Office Action Summary

10/563,359

RASANEN ET AL.

DETAILED ACTION

Figure 1

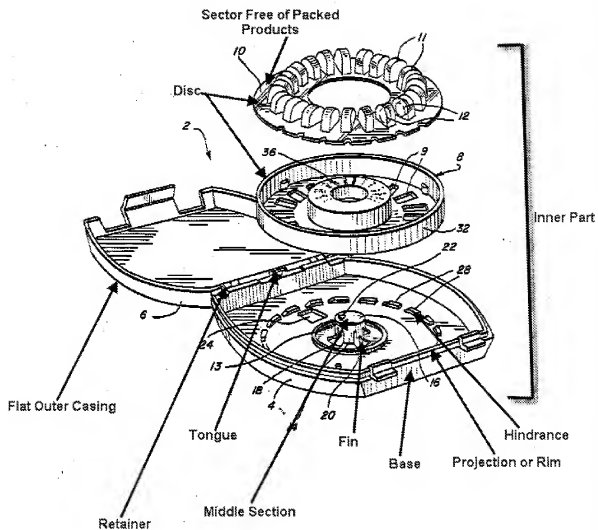
extractable inner part (that is available, obtainable or removable by opening the casing) having a disc formed as a blister package fitted rotatably onto a base (4), which has an outlet opening (24) below the disc so that products (12) brought to the opening by rotating the disc can be released from the disc by pressing the respective blister (11) and removed from the package through opening (24) (See marked up figure 1).

Regarding claim 2, Tump further discloses the casing (6) and/or the inner part is provided with a retainer, preventing the inner part from becoming loose from the casing (See marked up figure 1).

Regarding claim 4, as best understood in light of the rejection under 35 U.S.C. 112, second paragraph made in this action, Tump further discloses the disc containing individual products (12) arranged to form an arc of a circle or a ring so that they can be brought to the outlet opening (24) one at a time by rotating the disc (See marked up figure 1).

Regarding claim 7, Tump discloses the base being provided with a longitudinal outlet opening (24) extending in the direction of the radius of the disc (See marked up figure 1).

Regarding claim 9, Tump discloses the disc having a sector which is free of packed products and that in an unopened package the sector is located at or near the outlet opening (24) in the base (See marked up figure 1).

Regarding claim 10, Tump further discloses the disc articulated onto the base (4) from its middle section (22) (See marked up figure 1).

Regarding claim 11, Tump further discloses the extractable inner part having a base(4) and a projection extending from its side above the disc for keeping the disc in place on the base in an assembled configuration (See marked up figure 1).

Regarding claim 13, Tump further discloses the projection being formed as an annular rim encircling the circumference of the disc (See marked up figure 1).

Regarding claim 14, as best understood in light of the rejection under 35 U.S.C. 112, second paragraph made in this action, Tump further discloses the projection or rim having a tongue extending towards the center of the disc at which a blister in the disc is left under the rim (See marked up figure 1).

Regarding claim 16, Tump further discloses a tablet dispensing package made of flat sheets or panels or "packaging board" (See marked up figure 1).
